Title - Sujet Rayrock Remediation Project Rayrock Remediation Project	
Solicitation No. - N° de l'invitation EW699-220778/B	Amendment No. - N° modif. 008
Client Reference No. - N° de référence du client PCC-EW699-220778	Date 2021-11-09
GETS Reference No. - N° de référence de SEAG PW-\$NCS-003-12159	
File No. - N° de dossier NCS-1-44063 (003)	CCC No./N° CCC - FMS No./N° VME
Solicitation Closes - L'invitation prend fin at - à 02:00 PM Mountain Standard Time MST on - le 2021-11-16 Heure Normale des Rocheuses HNR	
F.O.B. - F.A.B.	
Plant-Usine: <input type="checkbox"/> Destination: <input type="checkbox"/> Other-Autre: <input type="checkbox"/>	
Address Enquiries to: - Adresser toutes questions à: Bilous, Isabelle	Buyer Id - Id de l'acheteur ncs003
Telephone No. - N° de téléphone (780) 782-8714 ()	FAX No. - N° de FAX (418) 566-6167
Destination - of Goods, Services, and Construction: Destination - des biens, services et construction:

This amendment is raised to modify solicitation EW699-220778/B as follows:

References in Drawing Notes and Sketch provided below:

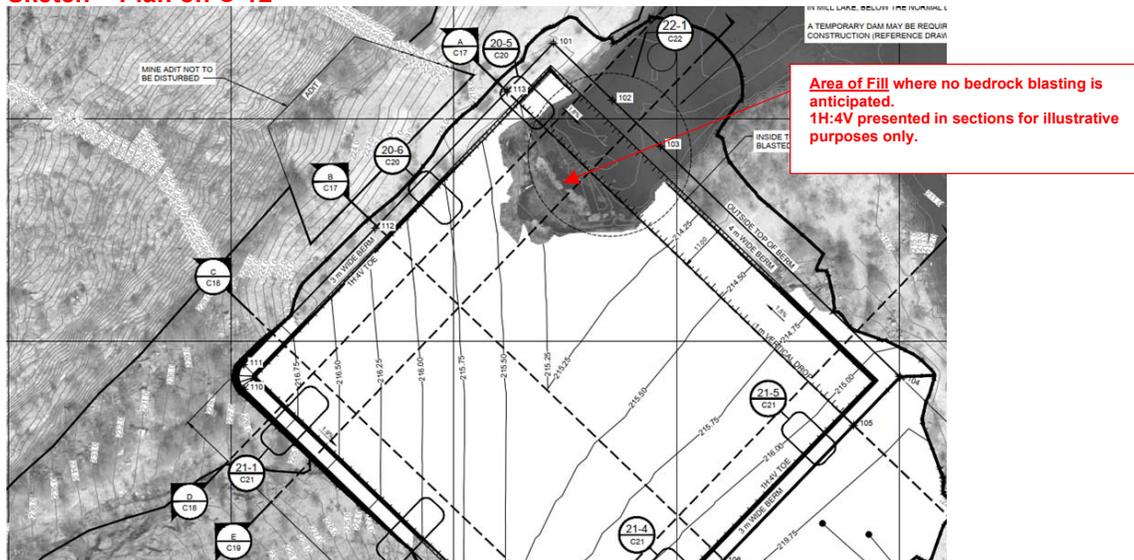
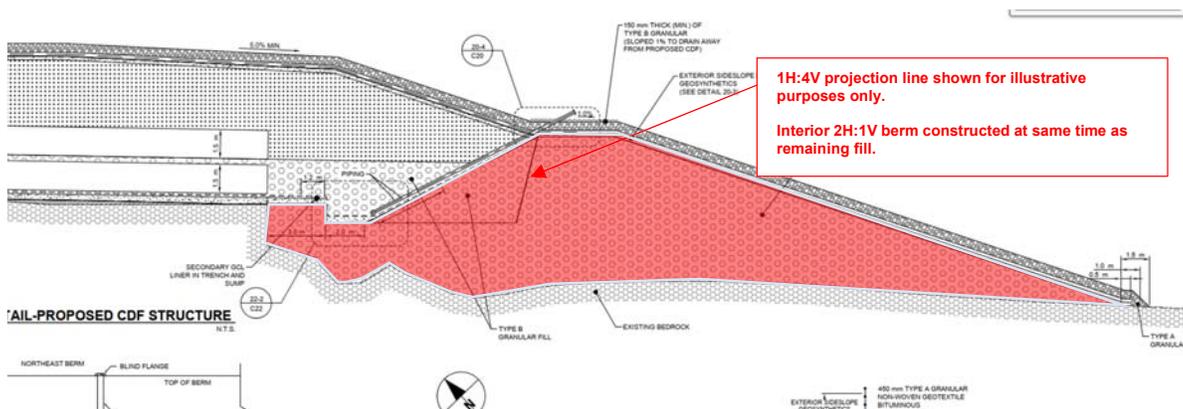
Question 118: Referring to Section D on Drawing C18, the berm section between chainage 110 – 125 indicates a 1:4 blasted bedrock cut slope, however this area is above original ground elevation. Please confirm that all earthworks to the left of Chainage 95 on this drawing (similarly for Section E) is all fill and that no bedrock blasted slope is possible. Revise slope details and sump location accordingly.

Answer 118: In areas where fill is required (such as the Mill Cove area referenced above) the expectation is that the 2H:1V interior berms would be constructed at the same time (as illustrated in DETAIL 22-1 on C-22). The location of the sump and other items take this into account and do not need to be revised. IFC drawing sections (C-17 to C-19) will be revised for clarity.

See Note 6 (C-12 and C-13):

THIS ROUGH GRADING SURFACE IS NOT CONSTRUCTABLE IN AREAS OF FILL AT 1H:4V SLOPE. THESE SHALL BE CONSTRUCTED AT THE SAME TIME AS THE BERMS (2H:1V). THE ROUGH GRADING SURFACE IS PRESENTED FOR CONSTRUCTION LAYOUT PURPOSES.

See Note 5 (C17-22):

CONTRACTOR SHALL REMOVE AREAS OF BEDROCK CUT, AS SHOWN IN THE DRAWINGS, PRIOR TO CONSTRUCTION OF BERM FILLS. AREAS OF ANTICIPATED BEDROCK CUT ARE SHOWN AS THOSE IN WHICH THE ORIGINAL GROUND IS ABOVE THE ROUGH GRADING SURFACE. THE ROUGH GRADING SURFACE INCLUDES THE PROJECTION OF A 4V:1H SLOPE FROM THE INSIDE TOP OF DESIGN BERM AS SHOWN IN THE DRAWINGS. IN THE ABSENCE OF A BEDROCK CUT, THE BERM (2H:1V) FILLS SHALL BE CONSTRUCTED AS SHOWN IN THE DRAWINGS.
